# MOTORSPORT SOUTH AFRICA

## MSA KARTING CIRCULAR 1/2008

## PORTS

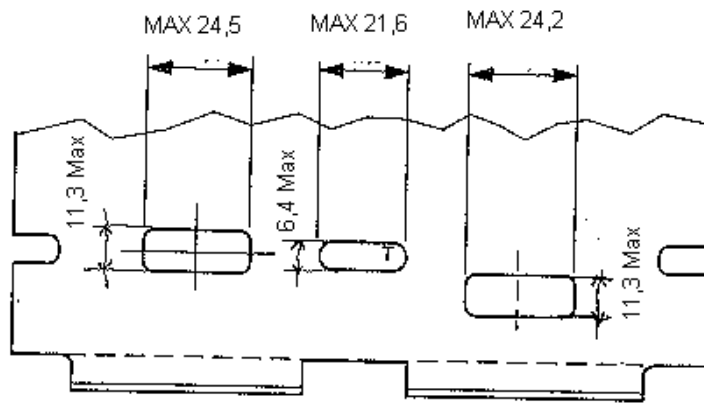
Junior GP competitors are advised that, when the change was made to the new-specification Comer W60 cylinders in 2006, the importer neglected to amend the figure for the transfer port maximum duration.

The correct figure is in fact 117 degrees (not 116 degrees) and a corrected version of the specification is attached hereto.

MAXIMUM DURATION INTAKE 129 DEG  
 MAXIMUM DURATION EXHAUST 150 DEG  
 MAXIMUM DURATION TRANSFER 117 DEG
